Comm 1160 5		NMOCD			
	UNITED STATES EPARTMENT OF THE INT BUREAU OF LAND MANAGI		ON Expi	ORM APPROVED 1B NO. 1004-0137 res: January 31, 2018	
SUNDRY NOTICES AND REPORTS ON WELLS Do not use this form for proposals to drill or to re-enter an abandoned well. Use form 3160-3 (APD) for such proposals.			<ol> <li>Lease Serial No. NMNM83197</li> <li>If Indian, Allottee or Tribe Name</li> </ol>

Plugging Procedure Farrell Federal #18 API – 30-041-20694 Sec. 28, T7S, R33E, UL-B 1310' FNL 1310' FEL

# Farrell Federal 18 30-041-20694 Ridgeway Arizona Oil Corp July 2, 2018 Conditions of Approval

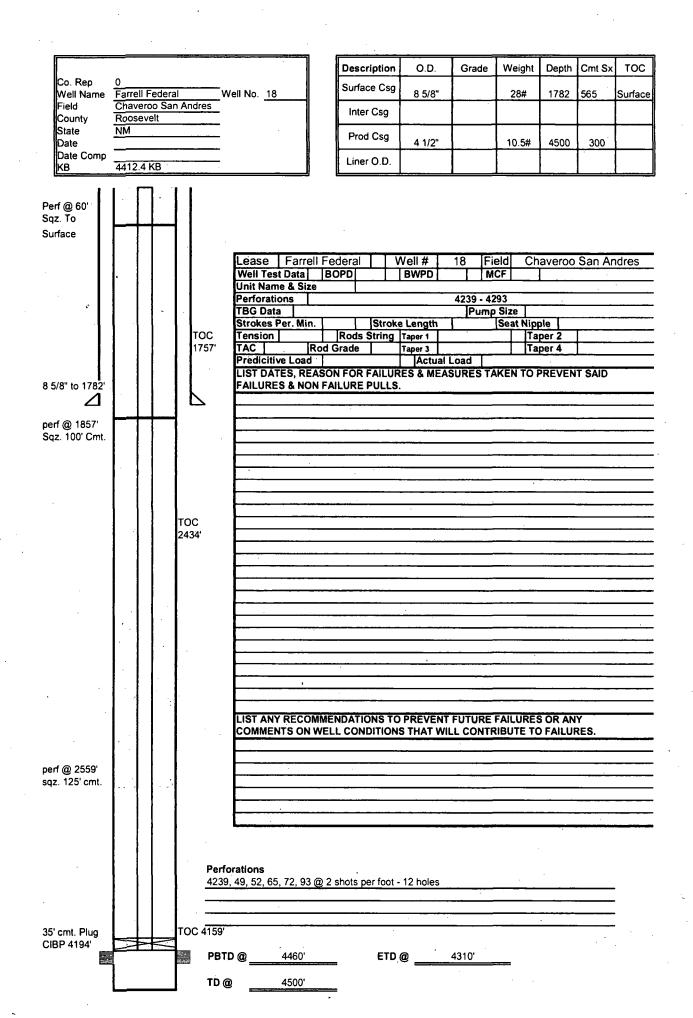
- 1. Operator shall place CIBP at 4,189' (50'-100' above top most perf) and place 35' of Class C cement on top as proposed. <u>WOC and TAG.</u>
- 2. Operator shall perf and squeeze as proposed at 2,559'. Operator shall place a balanced Class C cement plug from 2,559'-2,220' to seal the top of the Yates formation. <u>WOC and TAG.</u>
- 3. Operator shall perf and squeeze at 1,857. Operator shall place a balanced Class C cement plug from 1,857'-1,732' to seal the Shoe and the top of the Salt formation. <u>WOC and TAG.</u>
- 4. Operator shall perf and squeeze at 60' bringing cement to surface.
- 5. See Attached for general plugging stipulations.
